First Closure

DER Construction Permit No.: SC16-184444 County: Duval
Name of Project: Trail Ridge Landfill - Side Slope Closure of Units 5, 6, 7 & 8
Name of Owner: City of Jacksonville; Trail Ridge Landfill, Inc. - Operator/Permittee
Name of Engineer: England, Thims & Miller, Inc.
Type of Project: Class I Landfill - Incremental Closure
Closure of Units 5, 6, 7 (Partial) and 8 (Partial)
Cost: Estimated \$ 870,950 Actual \$ 738,700+/-
Site Design: Quantity: 2,600 (Avg) Ton/day Site Acreage: 5.0+/- Acres
Population: 659,000+/- (1990) Dumping Fees: \$ 55 /Ton
Deviations from Plans and Application Approved by DER: Deviations are shown
on the As-Built Drawing and/or outlined in the attachment. The As-Built survey
was prepared by Sunshine State Surveyors, Inc. and reviewed by England, Thims
and Miller, Inc.

DER Construction Permit No: SC16-184444 County: Duval
Name of Project: Trail Ridge Landfill - Incremental Closure
Name of Owner: City of Jacksonville
Name of Engineer: England, Thims & Miller, Inc.
Type of Project: Class I Landfill - Incremental Closure
Side Slope Units 1-4 (Partial), 7-8 (Partial), 12-17 (Partial) and 18-20
Cost: Estimate \$ 1,800,000 Actual \$ 1,569,240
Design: Qua

PHASE VD (WEST) - PROTECTIVE SAND LAYER THICKNESS VERIFICATION PLAN		ETM. NO. E02-001
			DATE: OCTOBER 1, 2002
			DRAWN BY: F.D.D
	TRAIL RIDGE LANDFILL, INC.		DRAWING NO: 1

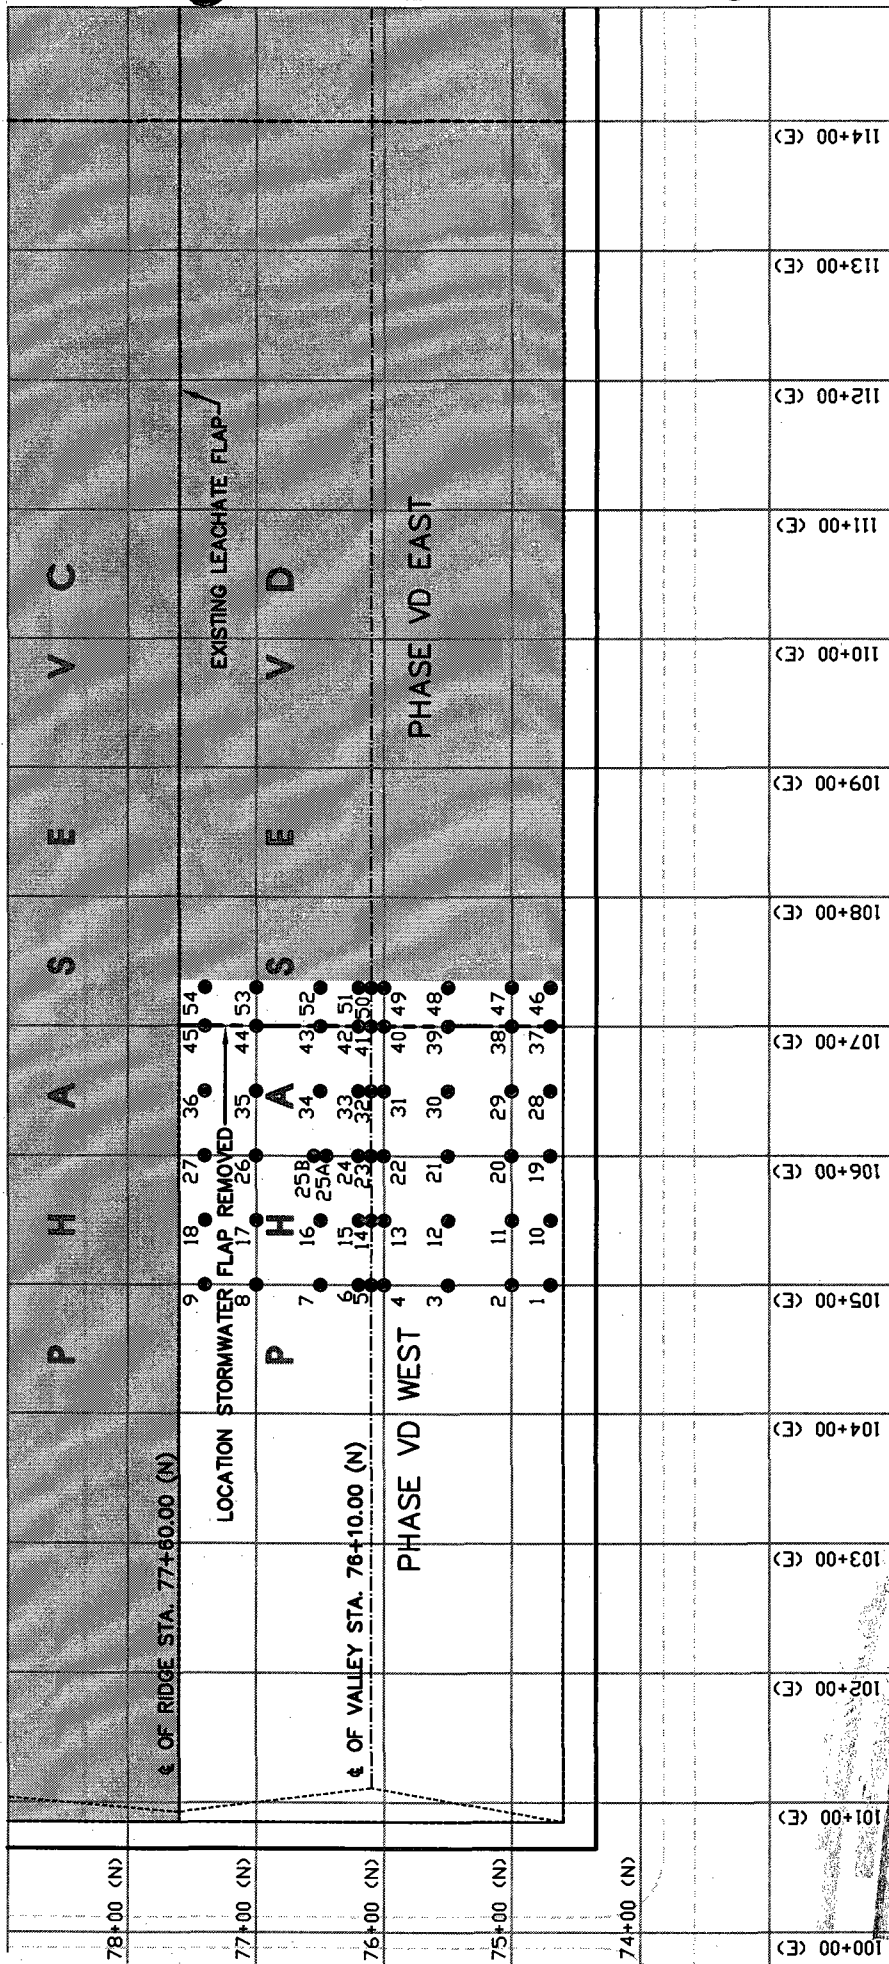
Note: England, Thims & Miller, Inc. Quality Assurance Monitor performed thickness checks in the areas of the silt removal and stormwater flap removal from Sta. 105+00 E to 107+30 E.

PHASE VD (EAST) - PROTECTIVE SAND LAYER THICKNESS VERIFICATION PLAN

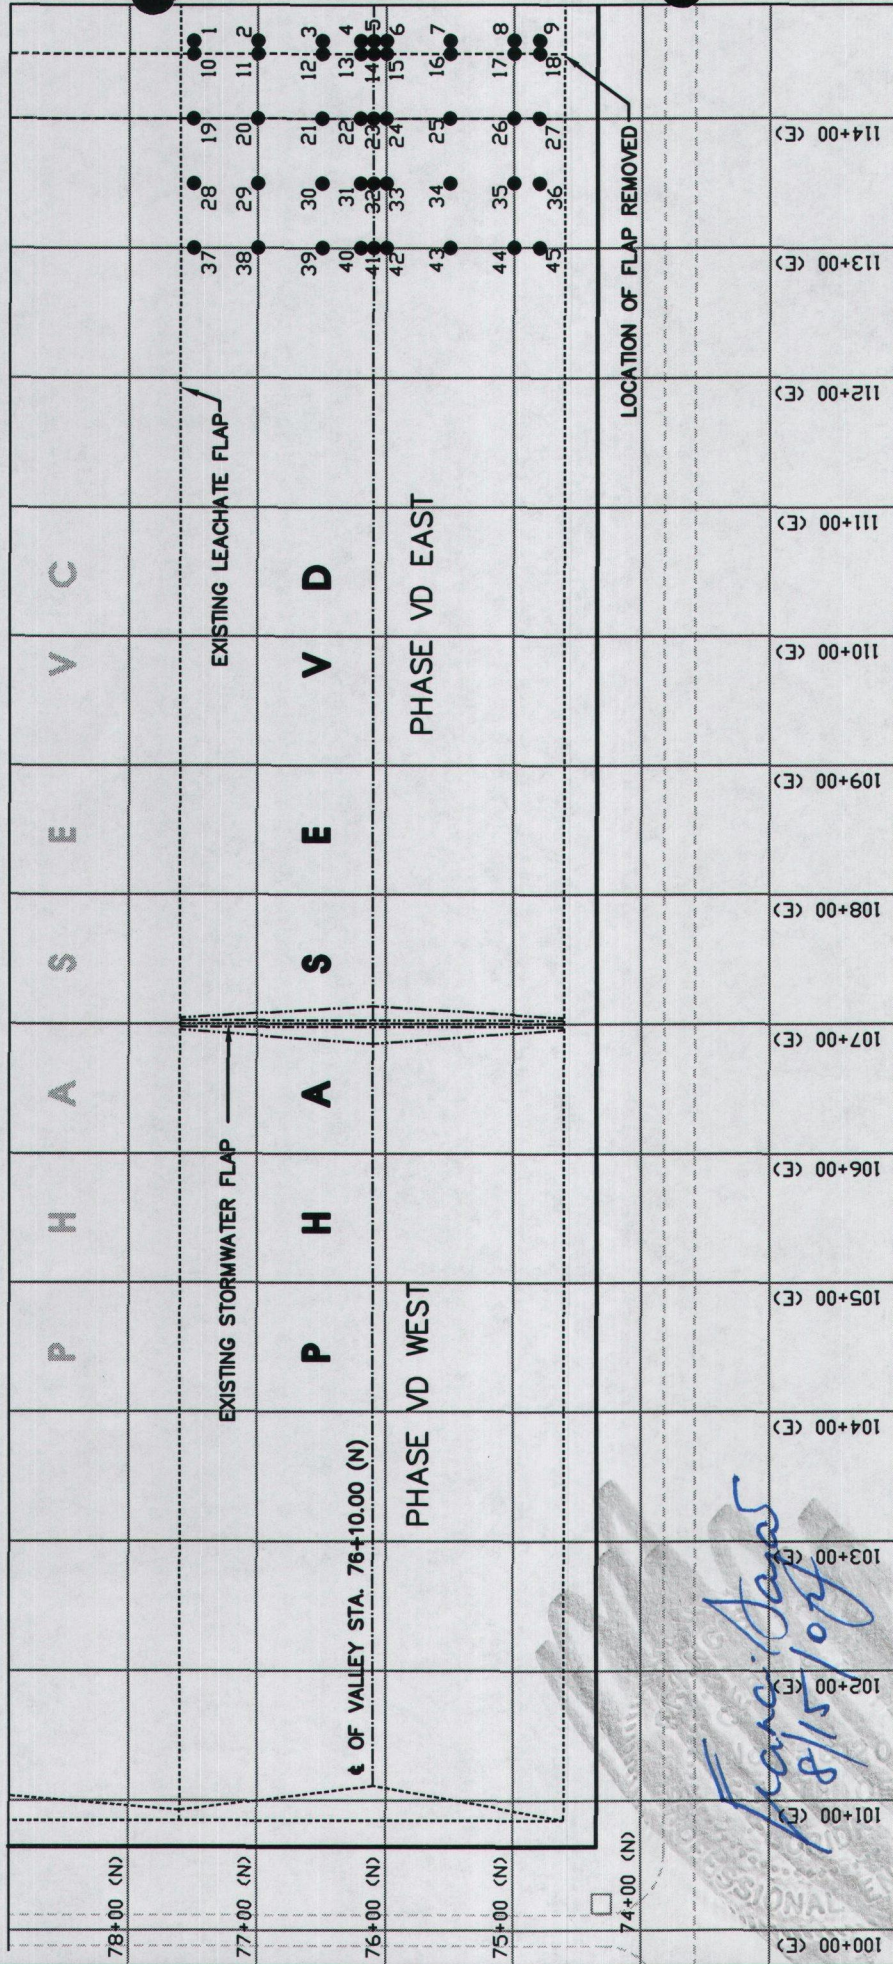
Note: ETM performed thickness checks only in the area of the silt and stormwater control flap removal from Sta. 113+00 E to 114+60 E.
